Subject: Docket No. 71-9270

Request for an Amendment of the UMS® Universal Transport Cask Certificate of Compliance (Approval Pending) to incorporate Maine Yankee Site Specific Spent Fuel, High Burnup Fuel and Damaged Fuel as Allowable Contents

UMS[®] Universal Transport Cask Drawing Changes

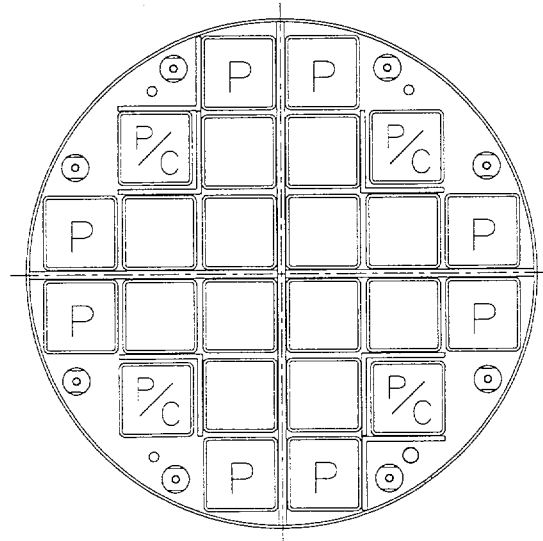
Chapter 1, Page 1.3.1-3	New figure “Preferential Loading Diagram for Maine Yankee Site Specific Spent Fuel”
Chapter 1, Page 1.3.1-3	Revision bar in 2 nd paragraph for text flow and “Maine Yankee” added before “site specific” and “are” is replaced with “include”
Chapter 1, Page 1.3.1-3	Added “High burnup fuel assemblies,” “fuel assemblies with start-up sources and other non-fuel items inserted in guide tubes,” and “damaged fuel” to bulleted list
Chapter 1, Page 1.3.1-4	Revision bar on 1 st and 2 nd paragraphs is for text flow
Chapter 1, Page 1.3.1-4	1 st paragraph, CEA acronym added, added “CEA flow plug, or thimble plug”
Chapter 1, Page 1.3.1-4	3 rd paragraph is new
Chapter 1, Page 1.3.1-4	Section 7.5.2.1 changed to Section 7.5.2 in last sentence of 4 th paragraph
Chapter 1, Page 1.3.1-5	Table 1.3.1-1, “Standard” number of assemblies revised, “Consolidated Fuel” canister loading position revised, “Burnable Poison Rod Replaced by Hollow Zircaloy Rod” canister loading position and canister class revised; Added “Burnup between 45,000 and 50,000 MWD/MTU,” “Maine Yankee Fuel Can,” “Inserted Start-up Source,” and “Inserted CEA Fingertips or ICI String Segment”
